## LAND USE APPLICATION - COMPLETENESS REVIEW

| <b>Subject Property:</b>          | 1793 Silverton Road NE                                                                                                                                                                                                        |
| <b>Reference Number:</b>          | 24-124647-PLN                                                                                                                                                                                                                 |
| <b>Application Type:</b>          | Class 3 Site Plan Review and Class 2 Adjustment                                                                                                                                                                               |

**Vehicle Turnaround**  
(addressed)

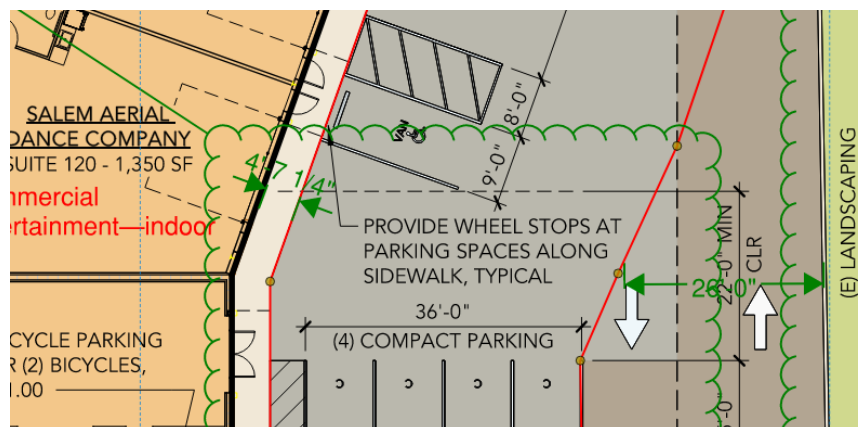
The area shown below terminates in a dead end. Per SRC 806.035(f), where a drive aisle terminates at a dead-end, a turnaround is required. Please revise the plans to provide a turnaround or reconfigure the parking area.

**Driveway Width**  
(addressed)

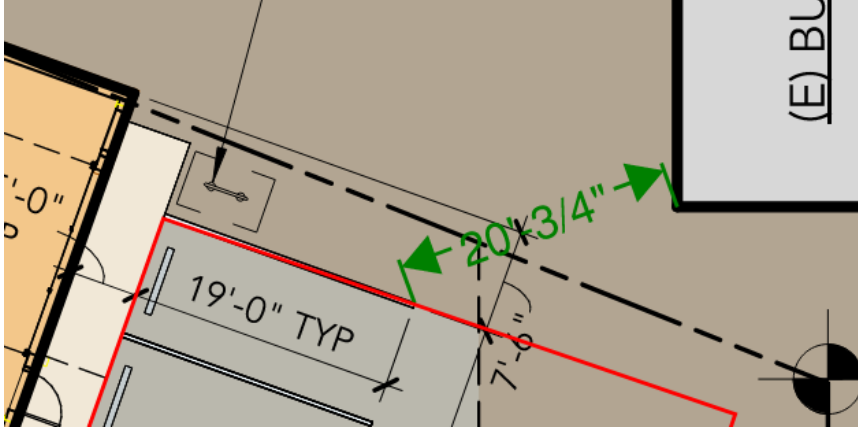
SRC 806.040 (d) requires a minimum width of 22 feet for two-way driveways. The proposed parking space narrows the width of driveway used to access northern property to less than 22 feet.

|                                              | <p>Please revise the plans to allow a 22-foot-wide driveway to allow access to northern property.</p>                                                                                                                                                                                                                                                                                                                                   |  |
